## Technical Service Information Bulletin

**M.I.L. "ON" DTC P0031, P0051, P2238,  
AND/OR P2241**

**'04 – '05 ES 330**

ENGINE  
EG003-05

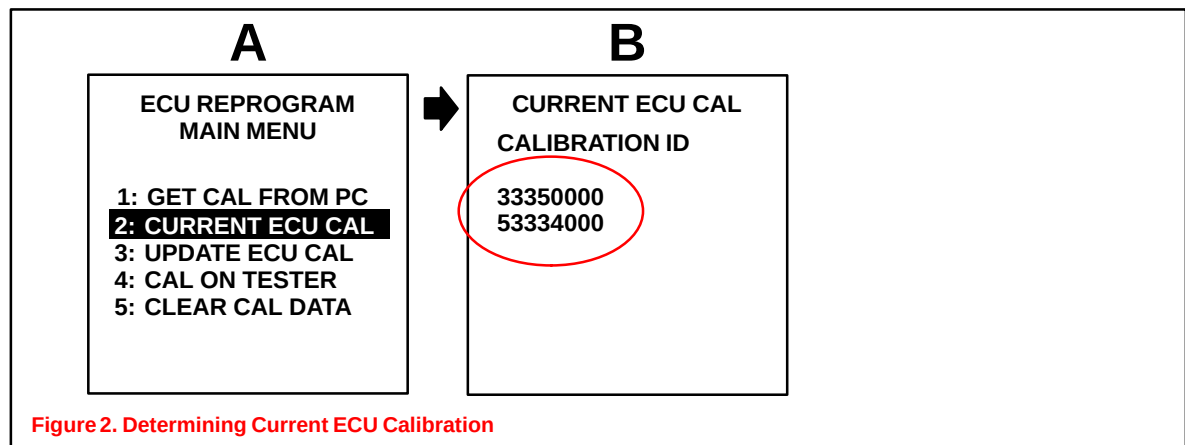
1. Replace both Bank 1, Sensor 1 and Bank 2, Sensor 1 air fuel ratio sensors.
2. Check for the Authorized Modifications Label affixed to the vehicle in the location shown in Figure 1. Confirm if ECM (PCM) calibration has been updated. If not the latest ECM (PCM) calibration — go to step 3.
